**Re: Thunder Bay Hydro Electricity Distribution Inc.
Application for Rates
Board File Number EB-2016-0105**

Ontario Energy Board Staff Supplemental Interrogatories
2017 Electricity Distribution Rate Application
Thunder Bay Hydro Electricity Distribution Inc. (Thunder Bay Hydro)
Expert Report (Yuri Tsimberg)
EB-2016-0105
May 30, 2017

Figure 2 - Weibull Probability of Failure Curves

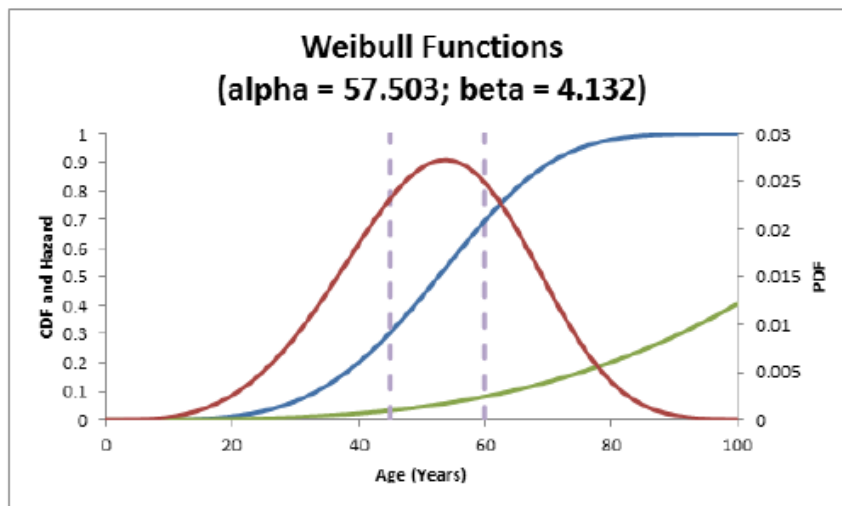
Failure density curve (the red curve) is first generated using removal statistics and then the rate of failure curve (the green curve) and probability of failure curve (the blue curve) are derived from the failure density curve. TBHEDI, like most other utilities, did not have sufficient removal statistics records required to generate the curves, so instead assumptions based on the experience of the TBHEDI's staff regarding typical useful life and extreme useful life of various assets were used to generate these curves. This is common practice amongst utilities who do not currently have removal statistics available. It is expected that going forward TBHEDI will start collecting removal information so that the risk assessment phase of the ACA process will improve in the future.

- a) Please quantify the ratio of the missing Thunder Bay Hydro removal data as a percentage of a complete data set, where 100% indicates that all required

removal data is available, and 0% indicates that none of the required data is available.

- b) How important is removal data when calculating utility-specific Health Index ("HI") values?
- c) To what extent does depending upon the opinions of experienced staff in the absence of complete actual removal data impact the confidence intervals associated with HI values? Please quantify.
- d) Are removal data typically categorized by driver, e.g.: does removal data separately track storm-induced failures, electrical failures, tree-fall failures, vehicle accident failures and premature retirements due to customer requests (such as road widening or business closures)?

Figure 3 – TBHEDI's 10-Year FFAP

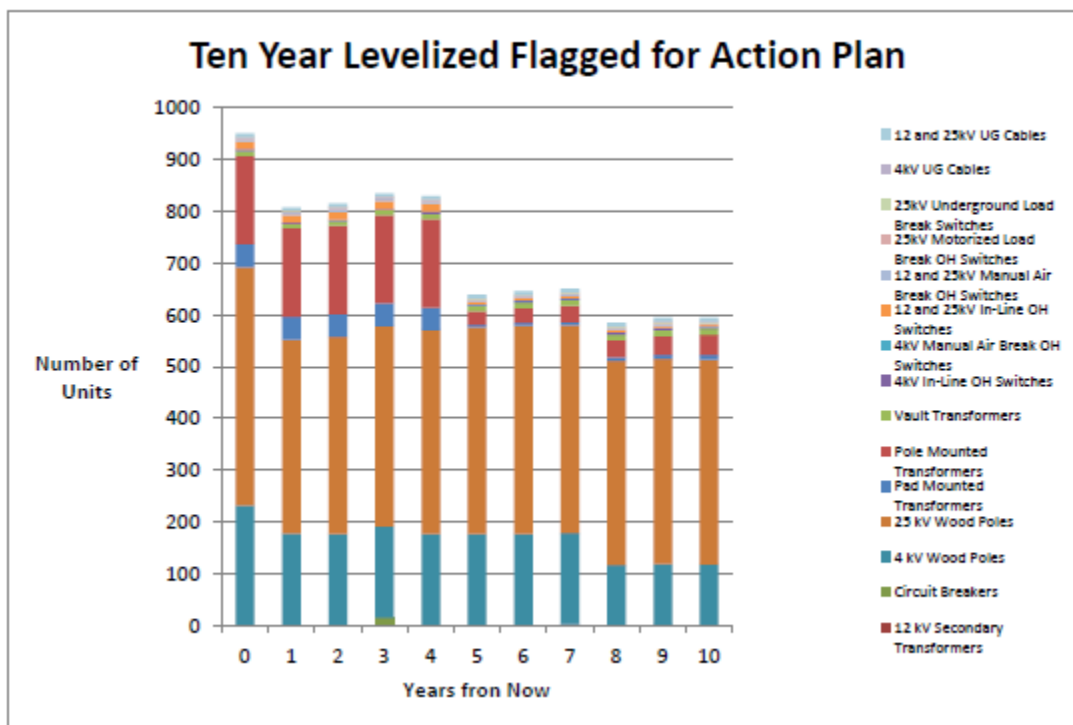
- Please explain the reasons for the significantly higher number of units flagged for action during the first five years (year 0 to 4) shown in Figure 3, and particularly the number of units in year 0. Please quantify the explanation, to the extent possible.

- Does the Flagged-for-Action Plan (FFAP) shown in Figure 3 incorporate the asset replacements forecast in the present filing? If not, please provide an updated version of Figure 3 that does incorporate the forecast replacements.

- What would be the anticipated reliability impacts of implementing a replacement program that was more evenly paced over the planning horizon shown in Figure 3?

- Please compare the FFAP with historical replacements for the 5 year period immediately prior to year 0 in Figure 3.
- Please explain the reasons for any significant (>10%) inter-annual unit flagged for action counts over the historical and planned horizons, by asset class.

Please correlate the TUL and Max UL values shown in Table 1 with the FFAP counts shown in Figure 3, i.e.: show how the year 0 replacement count for each asset class is related to the Table 1 TUL and Max UL values.?
